XK

417-05

TECHNICAL BULLETIN

Headlamp Misting – Improve Ventilation – Repair Procedure MODEL

ILLUSTRATION 1

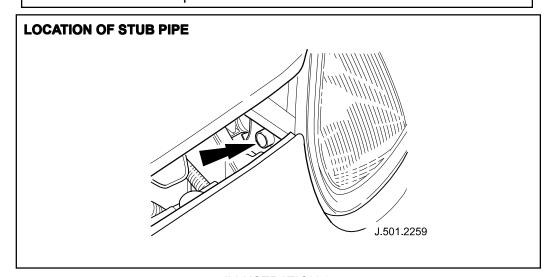
1. Inspect headlamp to see if stub pipe is present (Illustration 1).

Note: If stub pipe is present, continue with workshop procedure from step 2, if stub pipe is not present, obtain a new headlamp assembly and continue from step 3.

ILLUSTRATION 2

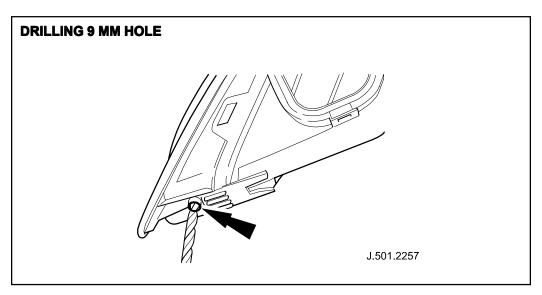
4. Carefully drill a 9 mm diameter hole upwards into headlamp using the stub pipe as a guide (Illustration 2).

Note: Maintain headlamp in the same orientation as for the drilling operation and shake out any drilling debris ensuring none remains in the headlamp.

ILLUSTRATION 3

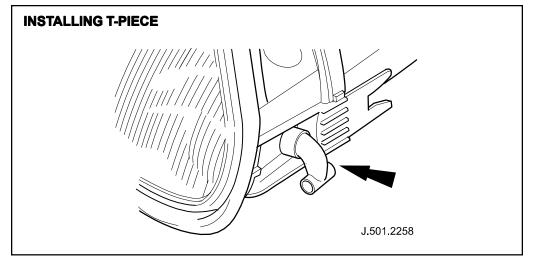
- 5. Place headlamp on clean bench.
- 6. Install and align T-piece to stub pipe (Illustration 3).

Note: Ensure headlamp stub pipe and T-piece mating surfaces are free from oil and grease.
